FAQ Number 10-0059 FAQ Revision 56

FAQ Title NFPA 805 Monitoring

Plant: Harris Nuclear Plant Date: _____
Contact: Joelle DeJoseph/Dave Phone: 919-546-6247/479-857-1975/402-825-5467
Miskiewicz/Jessica
Walker/Tom Shudak
Email: joelle.dejoseph@pgnmail.com
jwalker@jensenhughes.com/tgshuda@nppd.com

See revisions to NEI 04-02 Section 5.2.1, Section 5.2.3, and Appendix E below.

Figure E-1 – NFPA 805 Monitoring Process

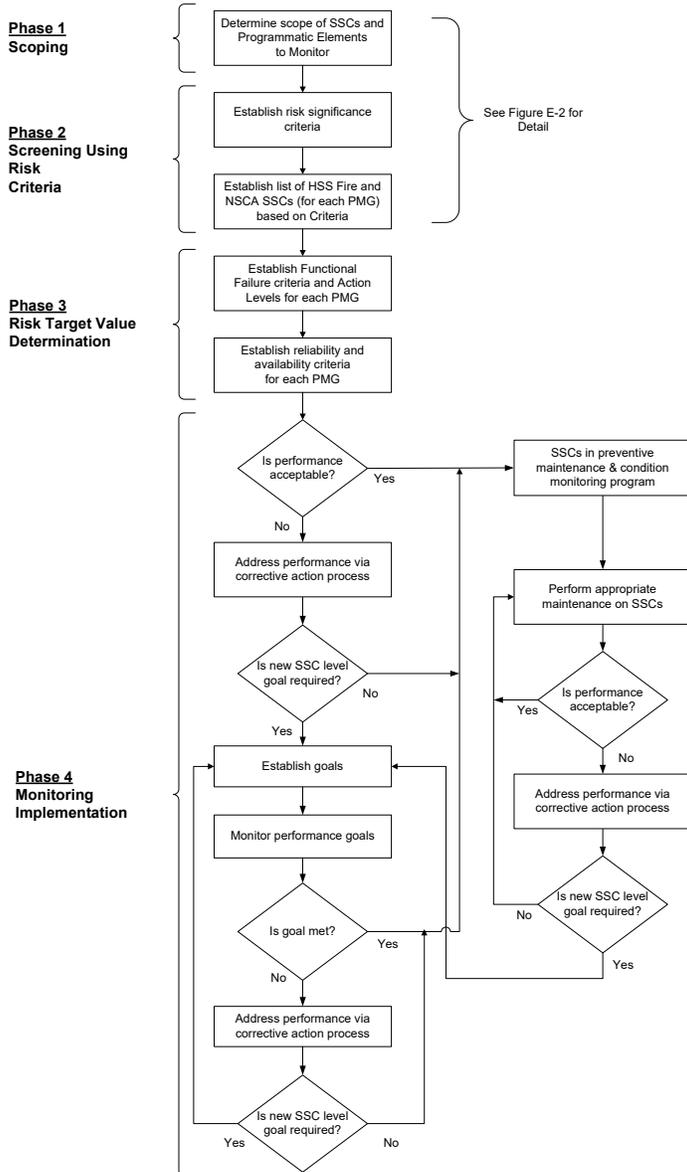
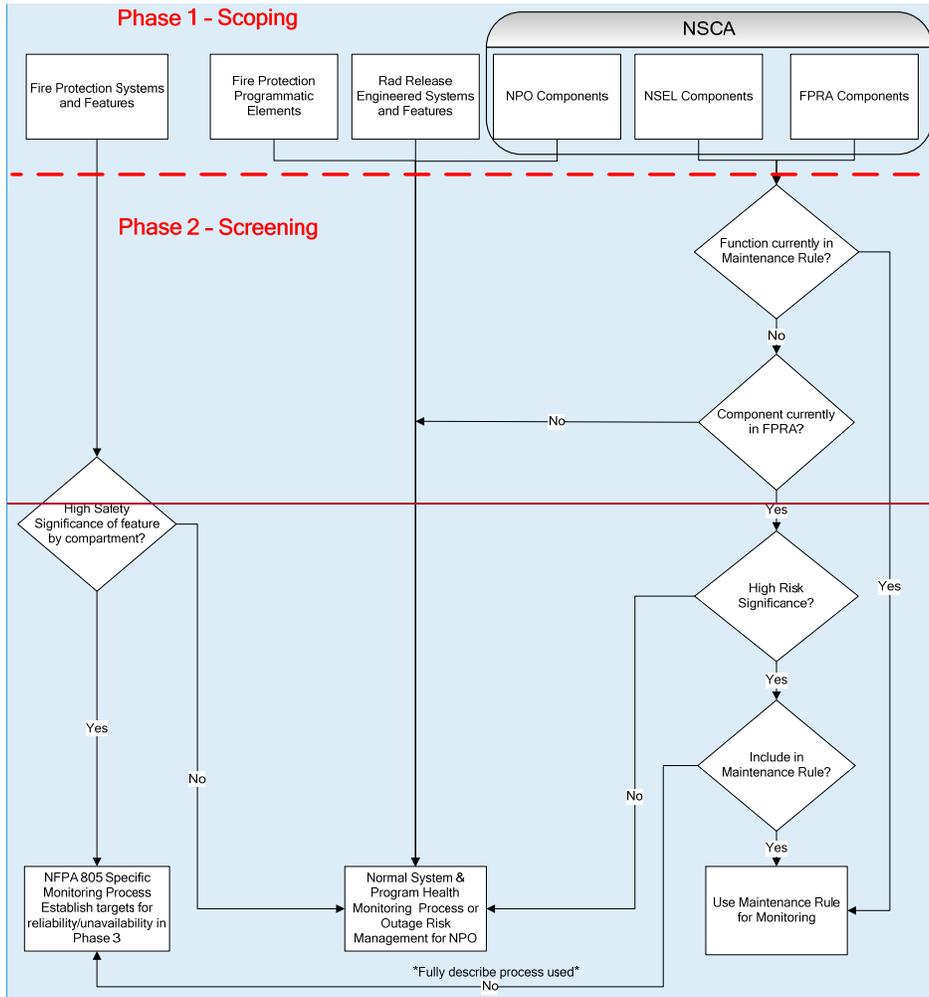
Commented [TS1]: SW - Should this have an item that says in MR as HSS, then follow Maintenance Rule?
